Dallas Parkway

DNT Frontage Roads

Plano Parkway to Park Boulevard

SUBJECT: North Texas Tollway Authority - Proposed Construction along DNT

Southbound Frontage Road

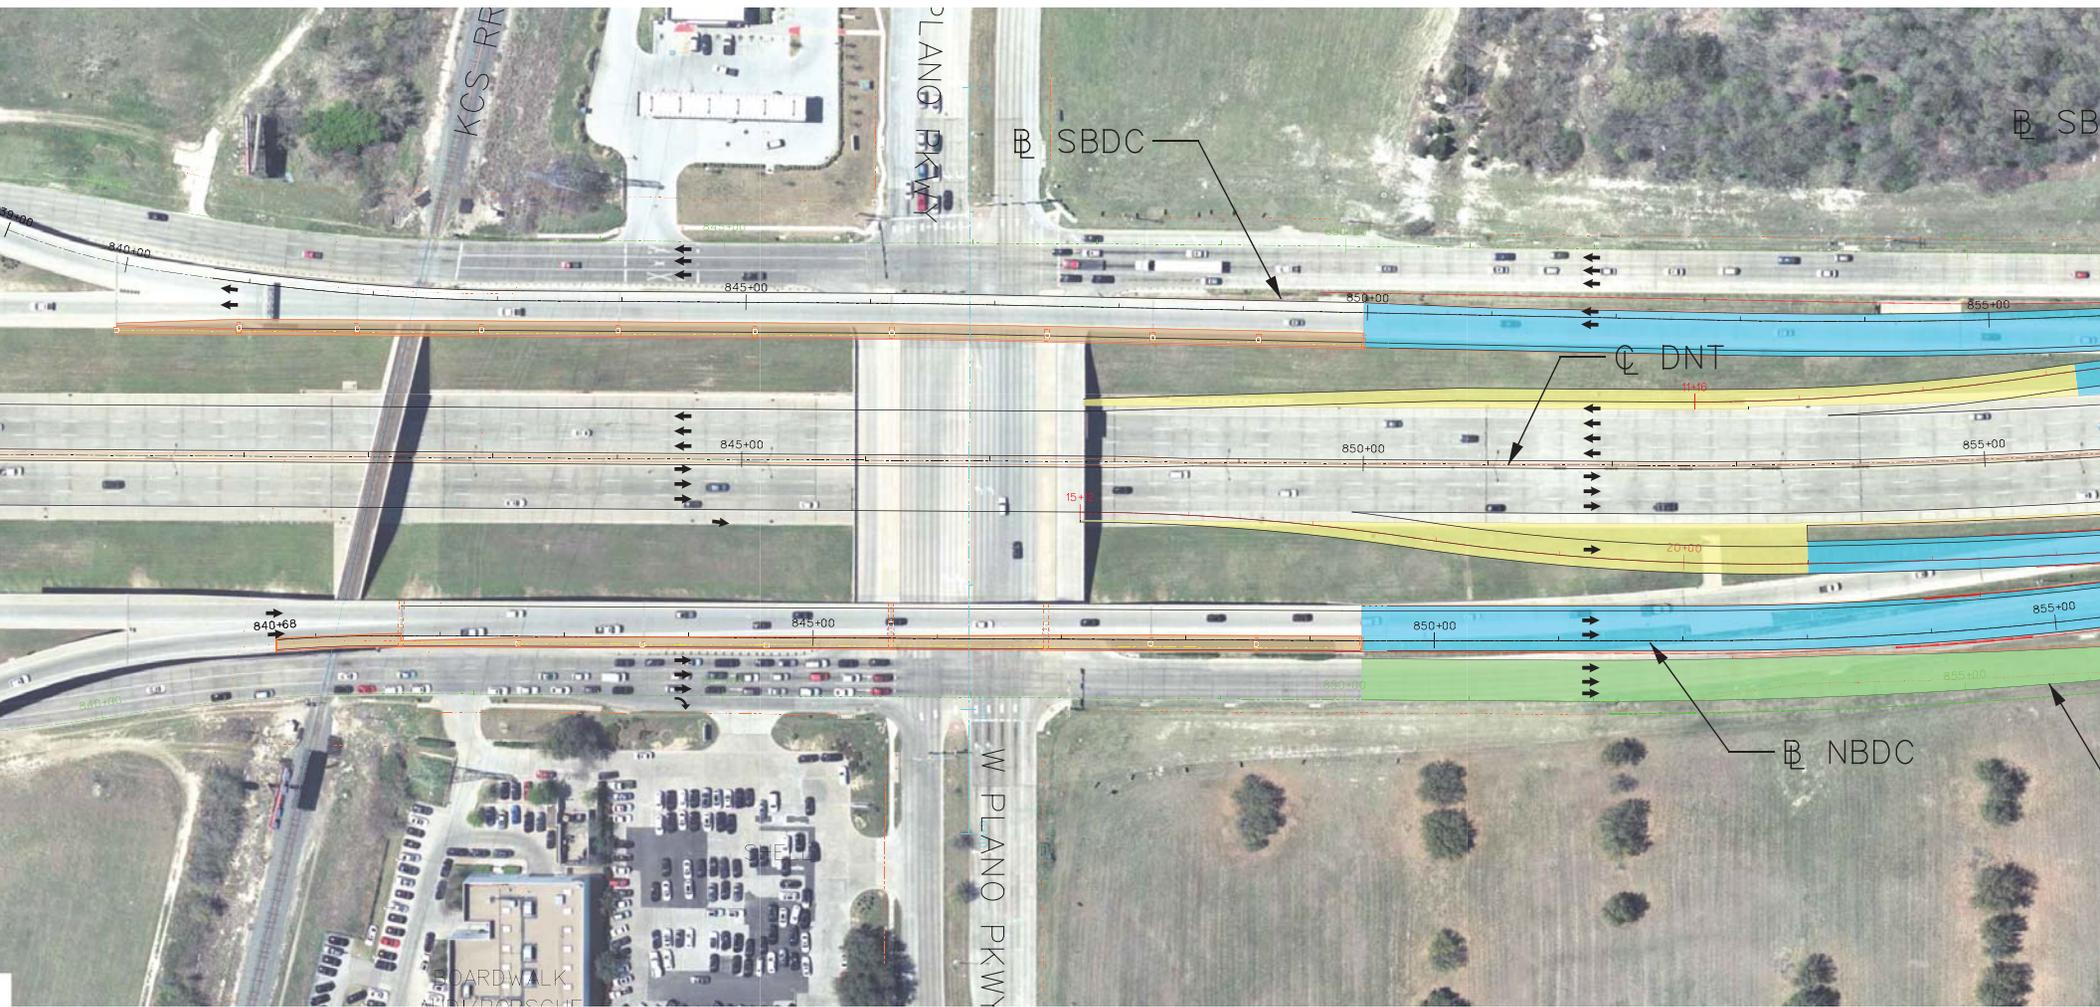
- Development has occurred in close proximity to the southbound frontage road and widening the frontage road to three lanes will damage the existing development; therefore, the option preferred by NTTA is to narrow the southbound frontage road from the existing three lanes to two lanes.

- While there will be a degradation in the level of service during peak traffic periods, the current traffic volume and future traffic volume on the frontage roads in this section can be accommodated by two lanes as proposed by the NTTA; therefore, staff recommends the City of Plano support the layout as proposed.

Northbound Frontage Road

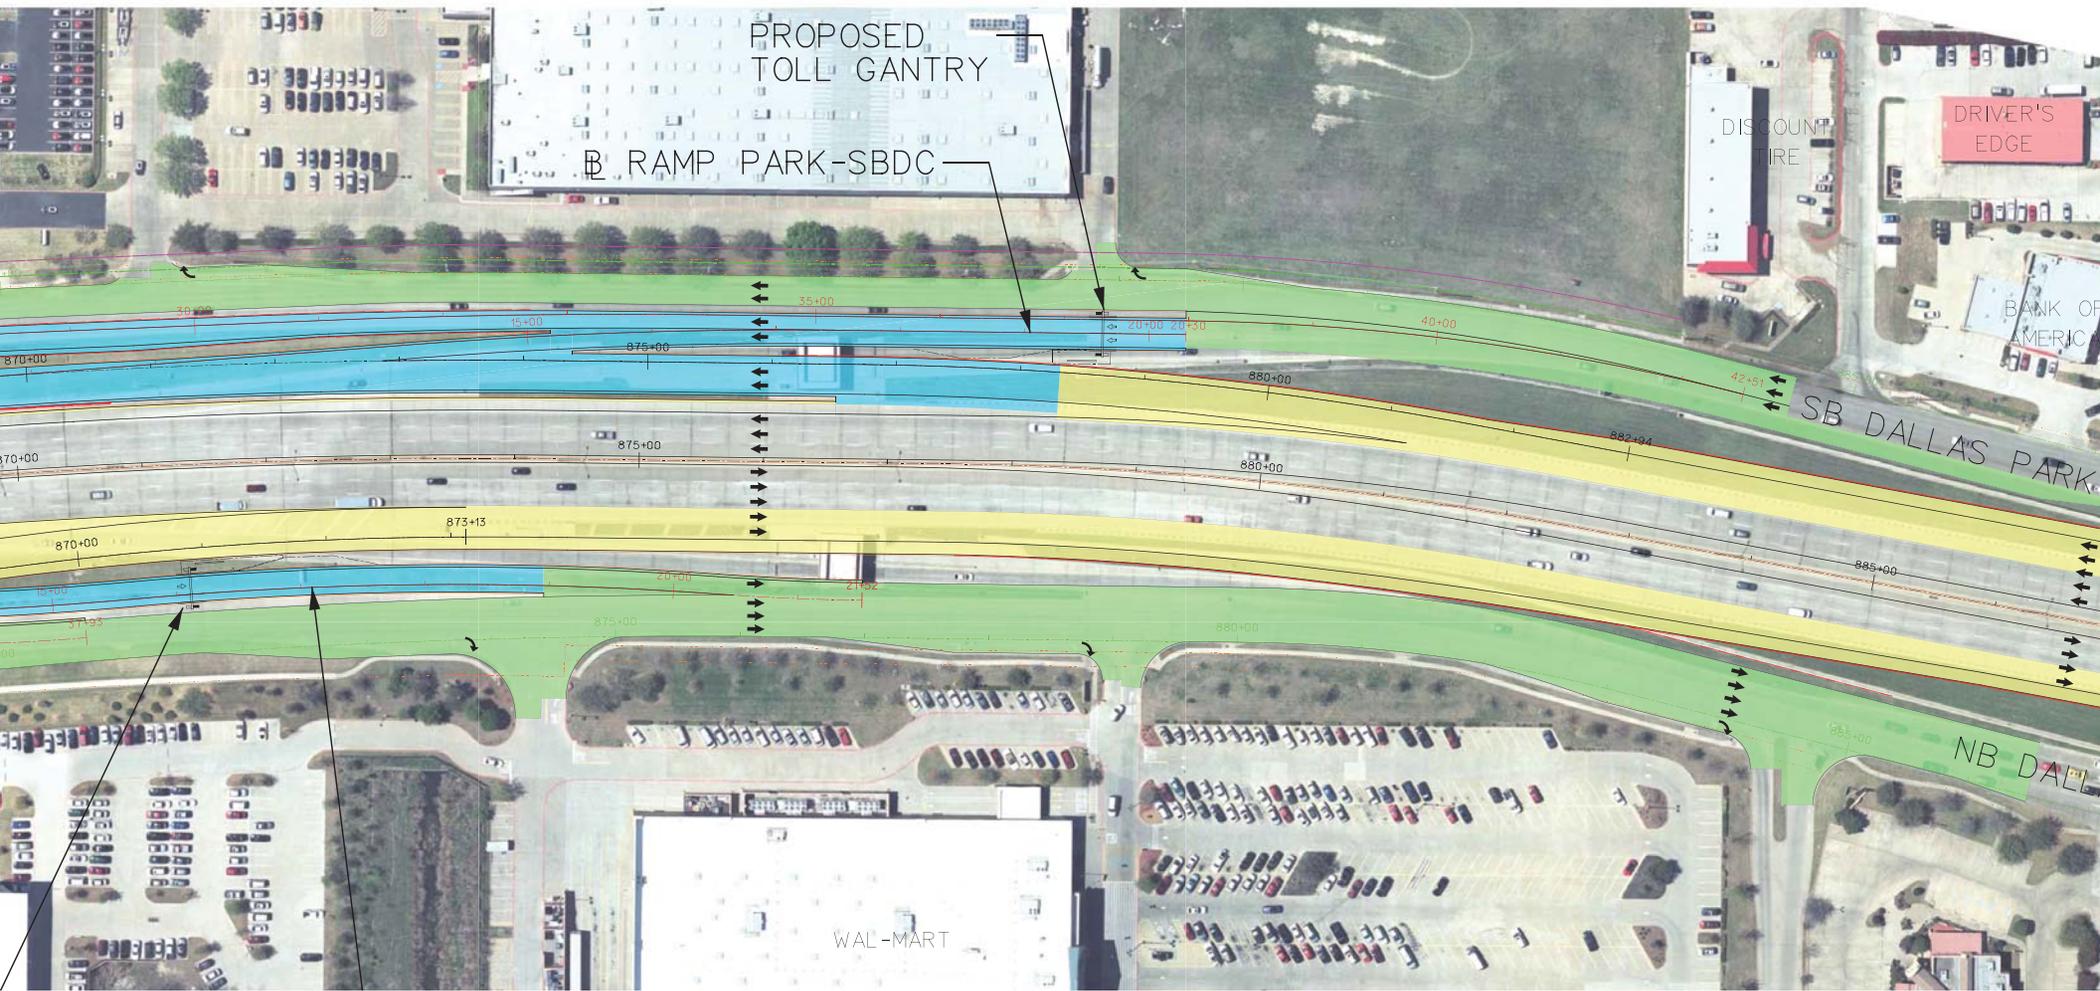
- On the northbound frontage road, land is available for the acquisition the right-of-way necessary to construct three lanes; however, the lane configuration is better with the two lanes as proposed. (The exit ramp flows into the third lane without the need to merge with frontage road traffic).
